**SSD\_7054: LEES 1 BUILDING AND SSD\_7055: F23 ADMINISTRATION BUILDING**  
**UNIVERSITY OF SYDNEY RESPONSE TO SUBMISSIONS**

The University of Sydney has reviewed all submissions received during the statutory public exhibition period of State Significant Application *SSD 7054 – F07 LEES 1 Building* and the *SSD 7055 – F23 Administrative Building*, both located on the southern edge of the University's Camperdown campus fronting City Road.

**Figure 2 Existing and Erroneous Layouts**

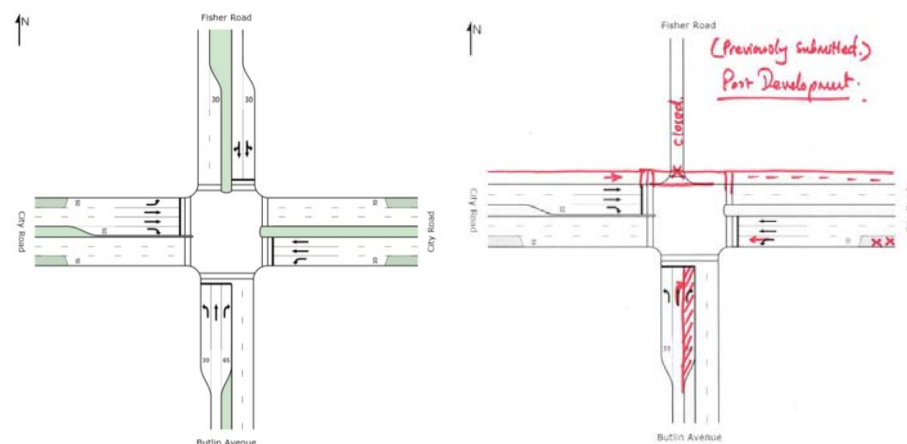
A detailed review of the previously submitted City Road/Butlin Avenue model revealed a geometrical error which resulted in the counter-intuitive output. Details are explained below.

The existing layout and previously submitted but erroneous layouts are shown on Figure 2 below.

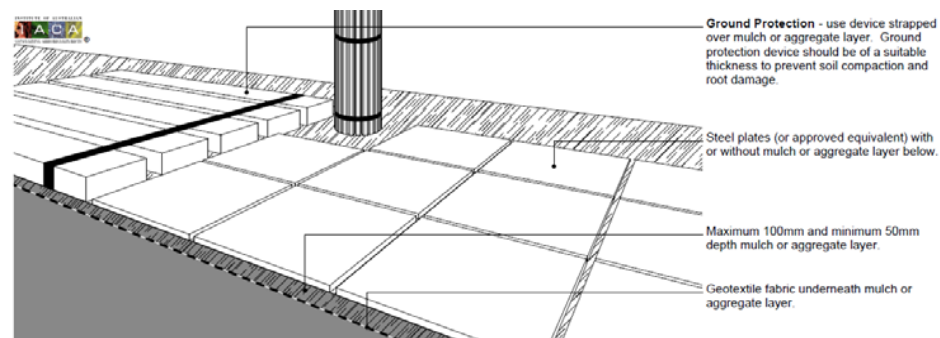
<p><b>2. Landscaping and Trees</b></p> <p>The amount of pruning [<i>of the Moreton Bay Figs on City Road</i>] anticipated in the report does not reflect the distance of the proposed building or allow for scaffolding/hoarding, building clearance and potential construction access associated with construction. Further, the report does not consider any future allowance for tree canopy growth which will inevitably occur each year.</p>	<p>The proposed LEES1 Building has been designed to minimise impacts to, and to preserve and maintain, the City Road Figs.</p> <p>As part of the design development stage, arborist specialist consultants <i>TreeIQ</i> determined the maximum amount of pruning acceptable based on an individual assessment of the trees' crown form and the constraints of Australian Standard 4373 Pruning of Amenity Trees (2007). The proposed building was sited based on the trees' crown form, following these pruning works.</p>

SSD 7054 – F07 LEES 1 BUILDING	
CoS ISSUE – LEES1	USYD RESPONSE
<p>Following a recent site inspection, it is considered that major pruning of T971, T972 and T973 will be required to facilitate construction. It is expected that the current design and scaffolding will require the removal of large primary branches (200 – 400mm diameter).</p> <p>To minimise the impacts of the new building on the significant fig trees, it is recommended that the building is setback further from the trees to allow a minimum distance of 2 metres from the edge of the existing canopy. This allows for scaffolding to be located within a 1 metre zone from the final edge of the building façade. Further, once the construction is complete it allows the tree 1 metre for growth, and 1 metre for clearance of the building facade. An accurate survey of the tree height, spread and crown shape should be undertaken and overlayed onto the proposed plans to ensure the setback is sufficient from the existing significant trees.</p>	<p>Stage 1 root pruning works were carried out in August 2105 in accordance with City of Sydney Notice of Determination TPR/2015/28, 16 July 2015. A copy the Notice of Determination is attached under <b>Appendix 1.01</b>.</p> <p>Stage 2 root pruning and crown pruning works were carried out on 29 July 2016 in accordance with City of Sydney Notice of Determination TPR/2016/228 dated 15 June 2016. A copy the Notice of Determination is attached under <b>Appendix 1.02</b>.</p> <p>As per Section 3.6.7 of the Arboricultural Impact Assessment (Rev D, 11.04.16), any additional pruning in sections of the trees' upper crowns to accommodate sections of the proposed building projection will be limited to branches no greater than 50mm diameter. This pruning work should represent terminal growth only which could be either pruned with hand tools from hoardings/scaffolding or temporarily pushed back.</p> <p>The proposed scaffolding (encompassing both the formwork support system &amp; edge protection) required to access the building edge during construction is temporary in nature and will be coordinated in conjunction with advice from the Arborist consultant.</p> <p>To protect the underlying soil from compaction temporary ground protection such as ground mats, steel road plates or approved equivalent will be installed.</p>

Indicative ground protection within Tree Protection Zone detail follows:

**Figure 1 Car Share spaces near the campus**

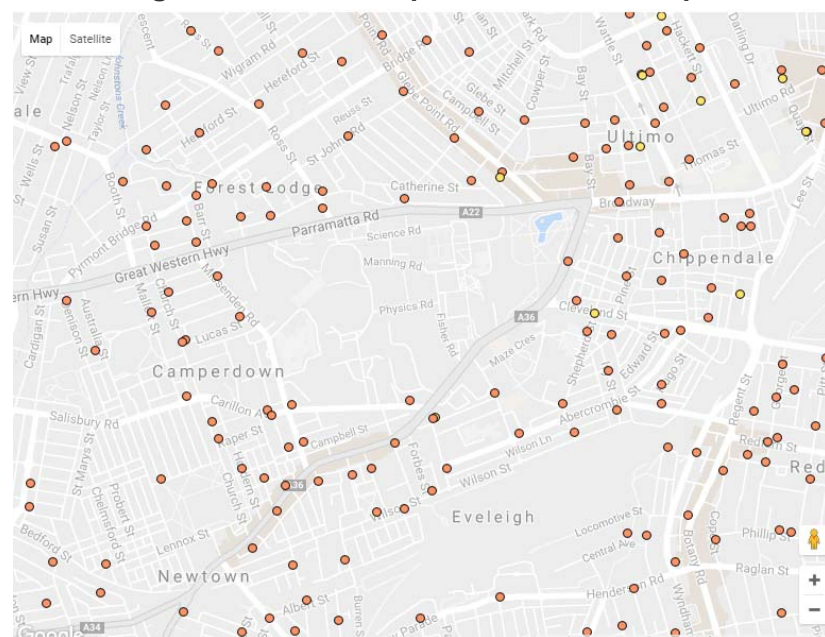
<p><b>3. Car share spaces</b> must be provided on site as per DCP12 Section 3.11.2.</p>	<p>The DCP car share requirement does not apply to tertiary education institution. However, the University notes that the areas surrounding the campus are well served by car share spaces (<b>Figure 1</b> overleaf).</p> <p>While there is no statutory requirement for such provision within the campus, the University and traffic consultants GTA support the appointment of a car share bay in the campus to service local students/staff. However, placement of these spaces within basement carpark is not ideal due to issues relating to accessibility and security. Therefore, should they be provided then it is recommended that they are located at ground level</p>

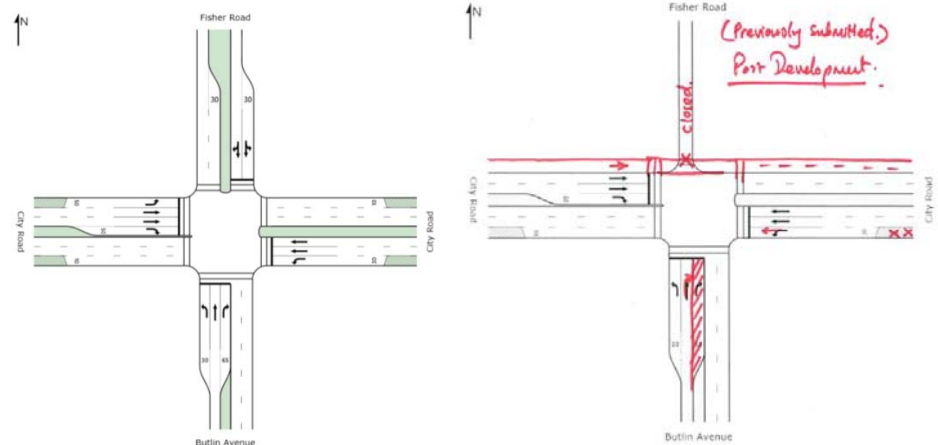
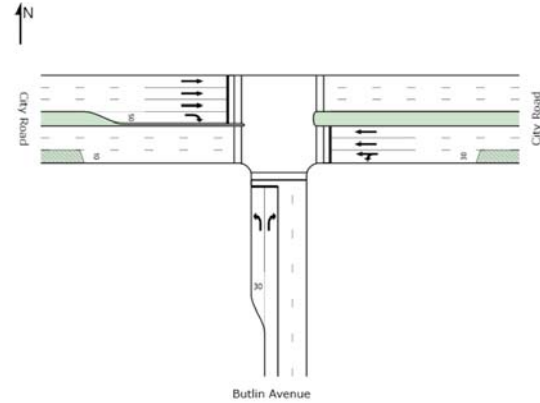
<b>SSD 7054 – F07 LEES 1 BUILDING AND SSD 7055 – F23 ADMINISTRATION BUILDING</b>	
<b>RMS COMBINED ISSUES – LEES1 &amp; F23</b>	<b>USYD RESPONSE</b>
<p>1. The traffic report submitted does not highlight the changes that were proposed at the meeting held with RMS and the consultants. Some of the notable changes were that the Fisher road access was to be left-in left- out with the median separation and access from the main gate entry was no longer being proposed with a T- Intersection type treatment bring the final layout. The report and plans show that there is an exit only from Eastern Avenue, which is the main entry gate and that's to be completely closed as per the updated information.</p>	<p>A detailed review of the previously submitted City Road/Butlin Avenue model revealed a geometrical error which resulted in the counter-intuitive output. Details are explained below.</p> <p>The existing layout and previously submitted but erroneous layouts are shown on Figure 2 below.</p> <p><b>Figure 2 Existing and Erroneous Layouts</b></p>  <p>The rectified layout which reflects the most recently proposed design is reflected on Figure 3 overleaf.</p>

<b>SSD 7054 – F07 LEES 1 BUILDING AND SSD 7055 – F23 ADMINISTRATION BUILDING</b>	
<b>RMS COMBINED ISSUES – LEES1 &amp; F23</b>	<b>USYD RESPONSE</b>
	<p><b>Figure 3 Submitted post-development configuration</b></p>  <p>Based on the above, the Sidra model has been revised to using the following parameters:</p> <ul style="list-style-type: none"> <li>• A three-legged intersection (i.e. T-Intersection)</li> <li>• Deletion of a northbound right turn bay</li> <li>• Appointment of practical cycle time because the intersection is now modified, and therefore readapted signal timings.</li> </ul> <p>The outcome of the revised model, which indicates satisfactory provision for both traffic and pedestrians are provided alongside of existing results in the Table overleaf.</p>
